LOCAL HISTORIC DISTRICT: Wesley Heights

PROPERTY ADDRESS: 1700 Heathcliff/Westbrook

SUMMARY OF REQUEST: Tree Removal

HDC-201900113

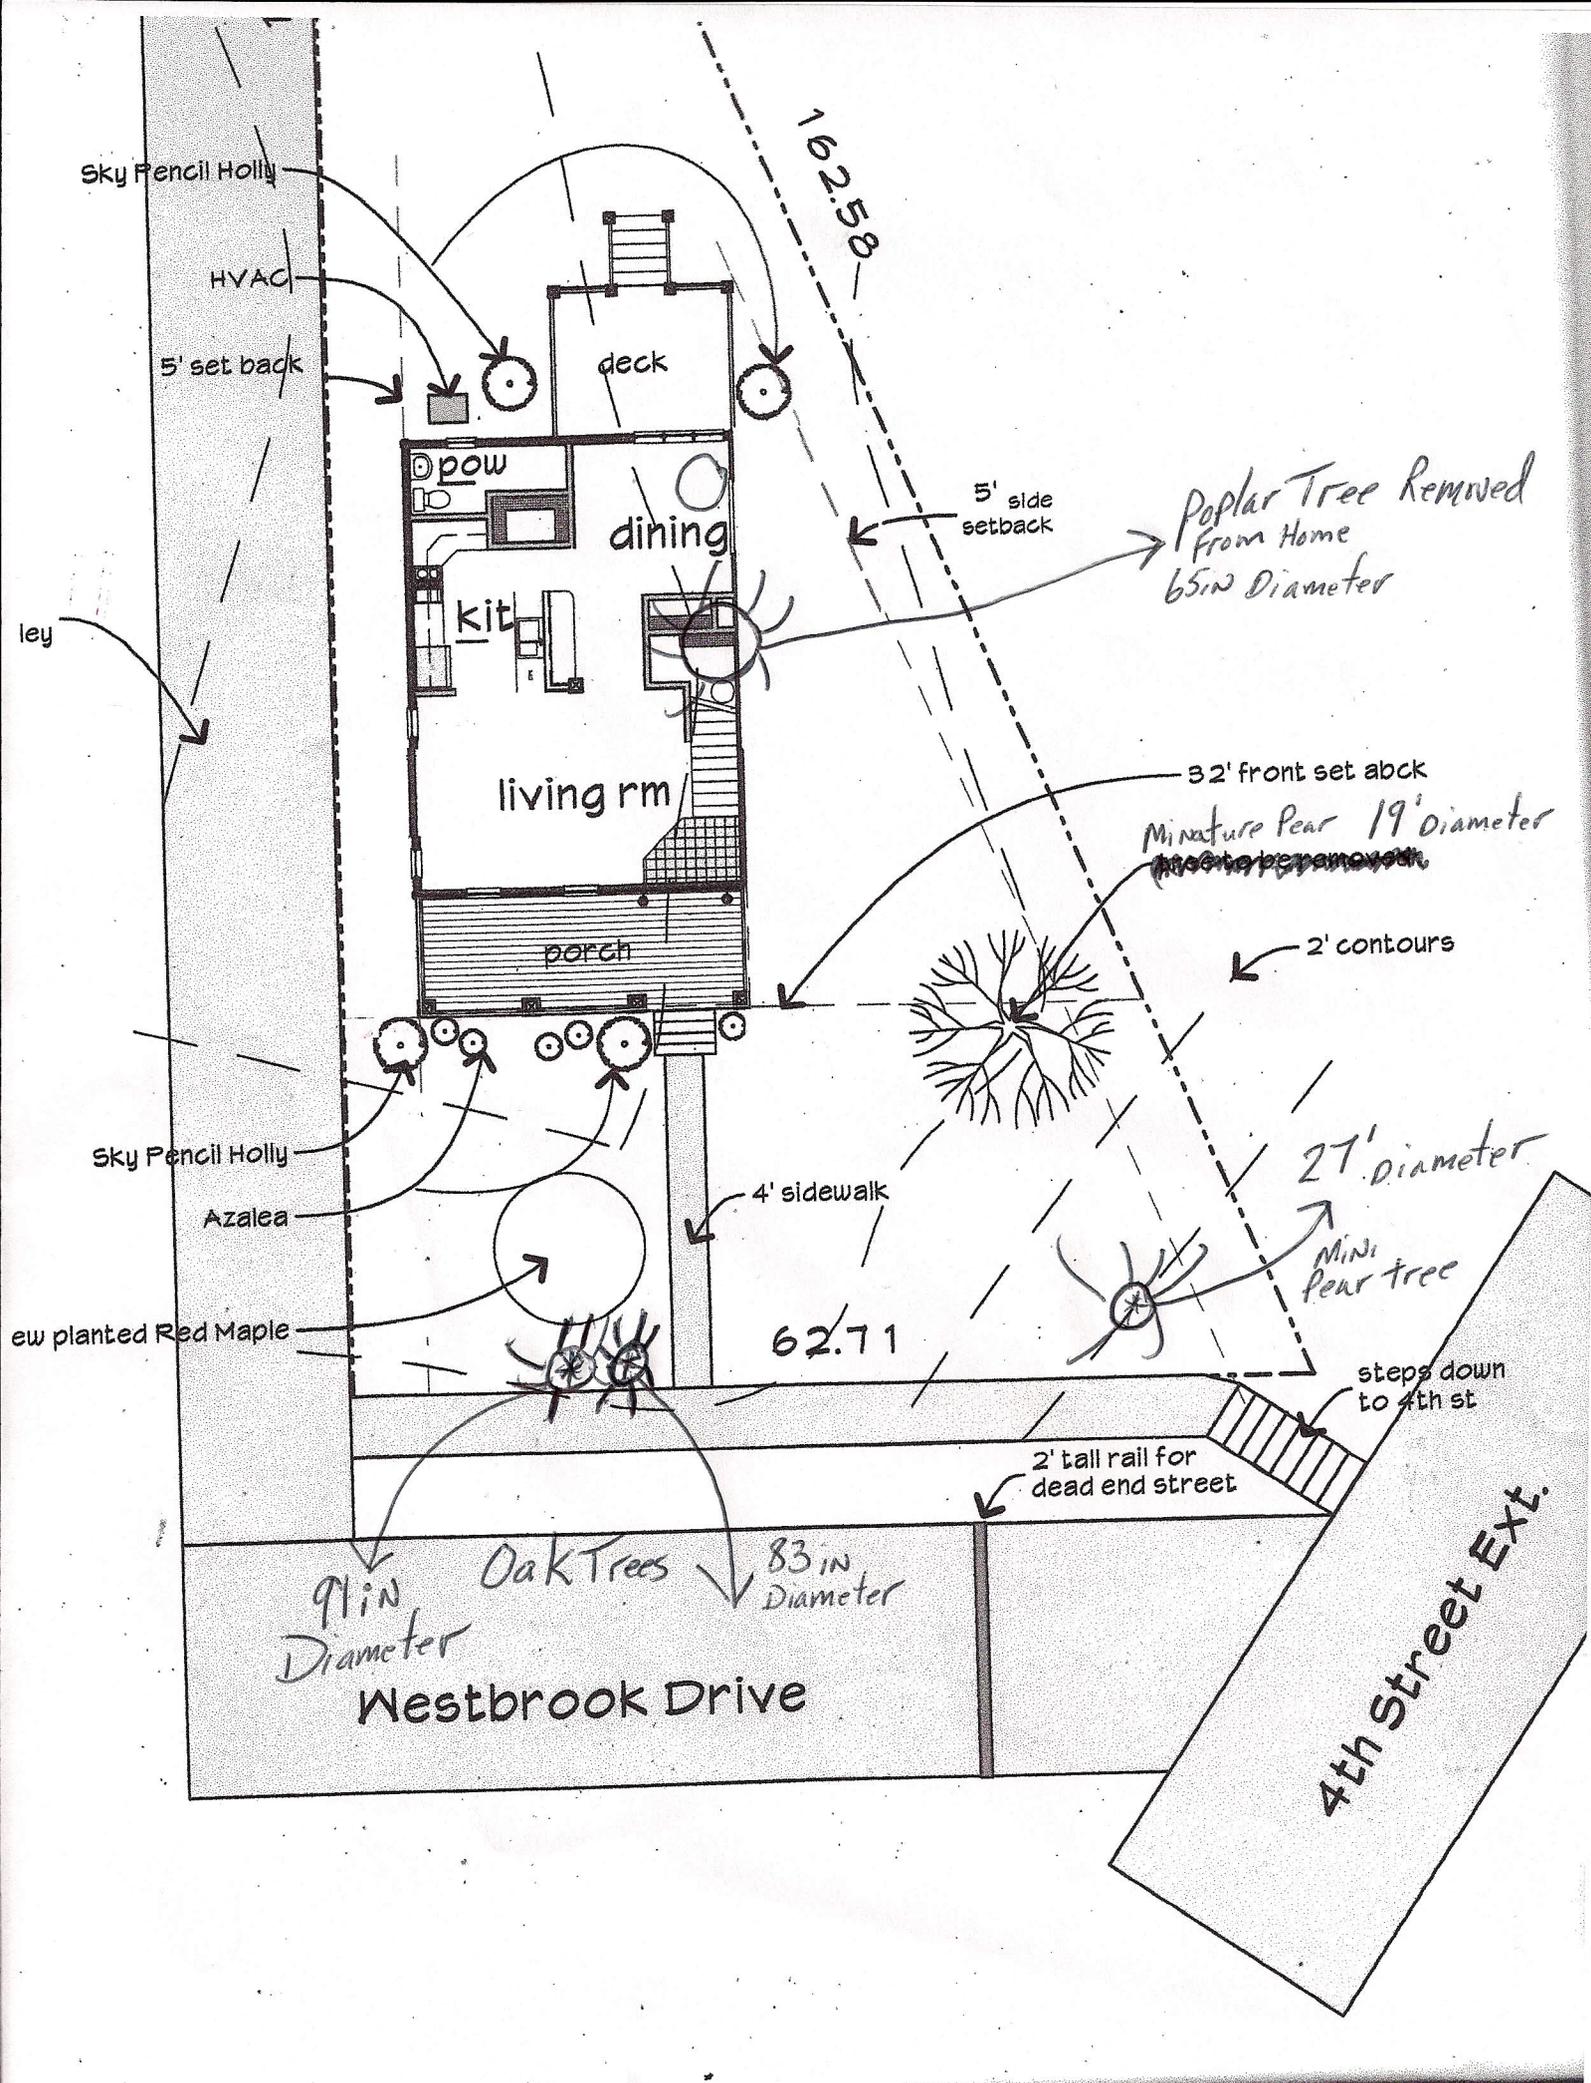
Poplar Tree Removed From Home 65in Diameter

32' front set abck
Miniature Pear 19' Diameter

27' Diameter
Mini Pear tree

91in Diameter
Oak Trees 83in Diameter
Westbrook Drive
